FMB110 Product Change Notifications

Product change notifications (PCN) is the way of informing customers of upcoming changes related to Teltonika products. This includes outward appearance adjustments, hardware improvements, firmware changes, changes to package contents, etc. This page stores information regarding changes to the FMB110 tracking device. Below you will find a list of both upcoming and already implemented changes sorted from newest to oldest (top to bottom).

2021.01.01: Top Laser Printing Changes

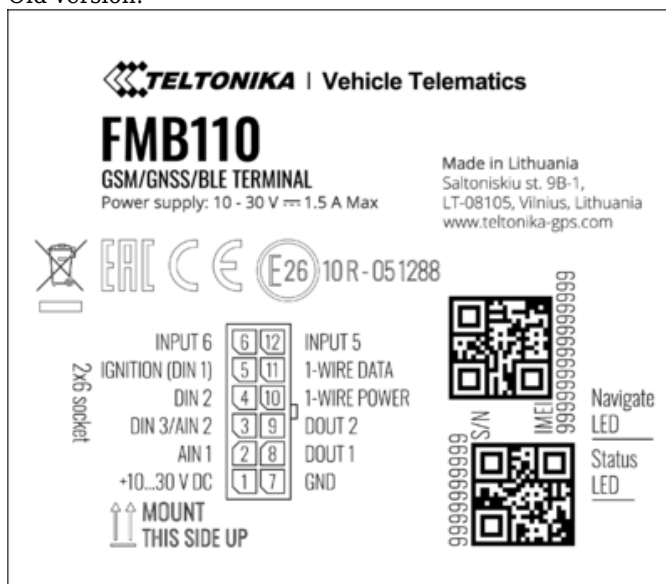
Change type	External/visual
	Top laser printing design changed
	Old version:

Change reasons	1. Updated Emark certificate number. 2. Added UKCA label. 3. Updated Teltonika brand to Teltonika Telematics.
Product release date	January 2021
